Project	IEEE 802.16 Broadband Wireless Access Working Group < http://ieee802.org/16 >
Title	Definitions for H-FDD mode in OFDMA
Date Submitted	2004-08-19
Source(s)	Intel. Yuval Lomnitz Yuval.Lomnitz@intel.com Noam Kogan Noam.Kogan@intel.com Yigal Eliaspur Yigal.Eliaspur@intel.com Dov Andelman
Re:	IEEE P802.16REVd/D5-2004
Abstract	Definitions for H-FDD mode in OFDMA
Purpose	
Notice	This document has been prepared to assist IEEE 802.16. It is offered as a basis for discussion and is not binding on the contributing individual(s) or organization(s). The material in this document is subject to change in form and content after further study. The contributor(s) reserve(s) the right to add, amend or withdraw material contained herein.
Release	The contributor grants a free, irrevocable license to the IEEE to incorporate material contained in this contribution, and any modifications thereof, in the creation of an IEEE Standards publication; to copyright in the IEEE's name any IEEE Standards publication even though it may include portions of this contribution; and at the IEEE's sole discretion to permit others to reproduce in whole or in part the resulting IEEE Standards publication. The cont

Figure 1 – example of efficient H-FDD operation

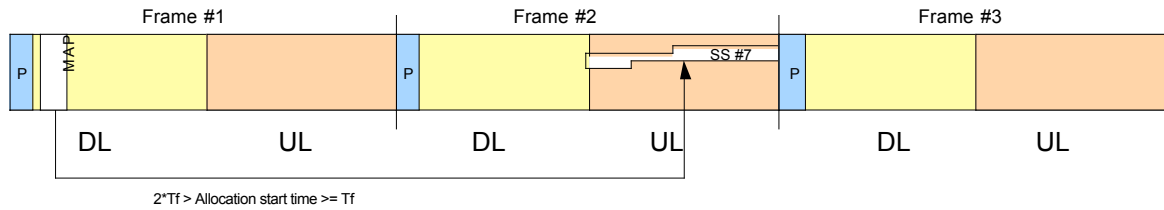
The UL map relevance is 3 frames ahead, which is similar to UL map relevance of 1 frame ahead in a TDD system with a double frame duration (see figure below).

The following figure illustrates the solution:

Figure 49a – MAP relevance for H-FDD in OFDMA PHY

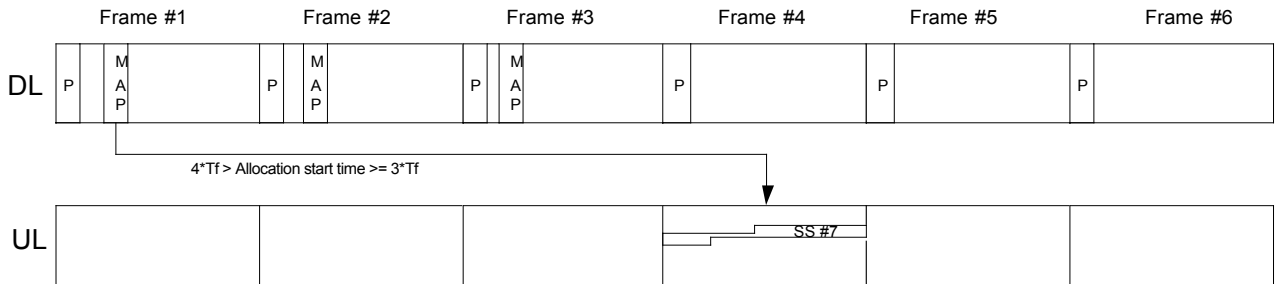
For FDD, the Allocation Start Time shall be subject to the following limitations:

- Minimum value: Allocation Start Time $\geq 3 * T_f$
- Maximum value: Allocation Start Time $< 4 * T_f$

[add figure 49a]
